October 3, 2025

This Addendum consists of the following:

PROJECT :
CITY & BOROUGH OF YAKUTAT
WATER SYSTEM EXTENSION

YAKUTAT, ALASKA

C-501 SCALE: N.T.S

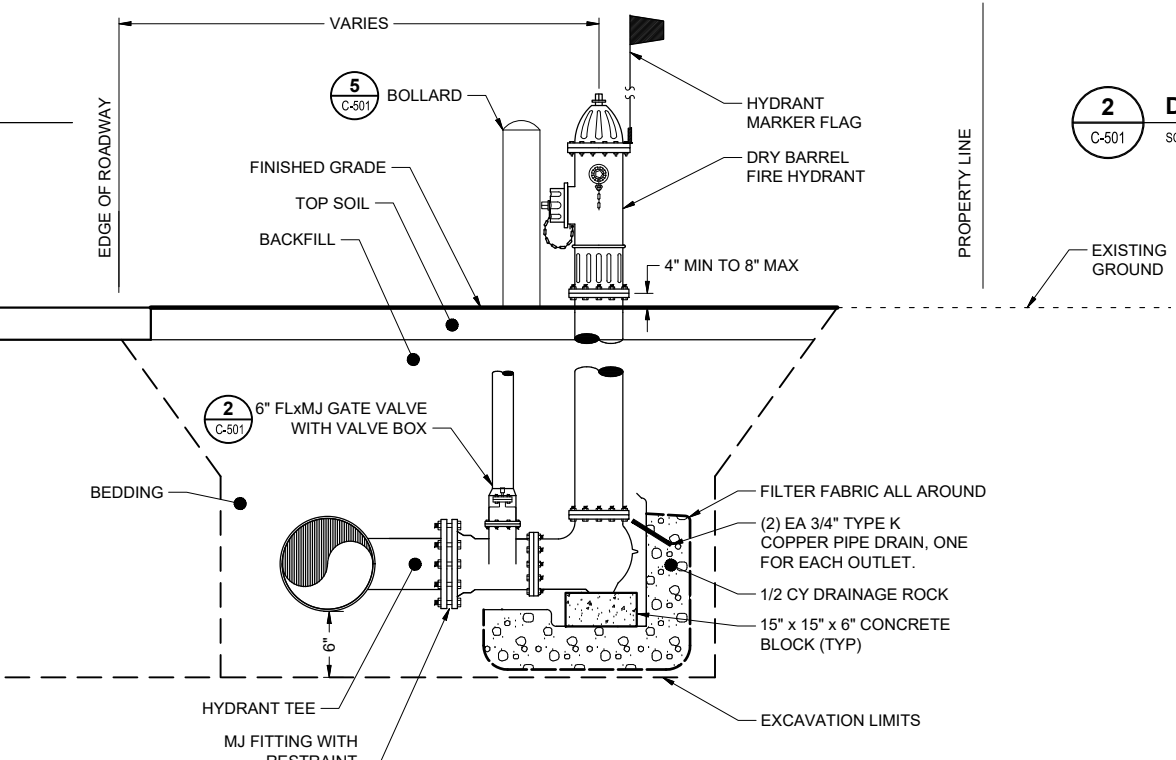
4. **QUESTION:** C-501/Det.1 Pea Gravel Bedding: Both groundwater and contamination greatly amplify the complexity of this project. As trench installation advances, the installed Pea Gravel Pipe Bedding will act as an unrestricted highly permeable conveyance to the active-edge of the trenching operation. This increases risk of cross-contamination migrating beyond present day limits, requires more extreme dewatering solutions, and adds complexity to Yakutat’s future maintenance team repair efforts because they’ll have thousands of feet of water in the capillary voids. To retard flows through the new alignment and isolate regions, it seems prudent to add a line item for Bentonite Trench-Dams spaced every X-hundred feet apart.

RESPONSE: The use of pea gravel bedding is not going to increase the risk of cross contamination. Soil borings show sand and gravel materials at the water main depth. These materials allow groundwater migration. Check dams will likely be needed to retard groundwater flow to aid in the dewatering process. We have seen success with silt materials in similar alluvial soils spaced in 200’ intervals but this is not a requirement of the contract. It will be up to the Contractor to propose the mean and method.
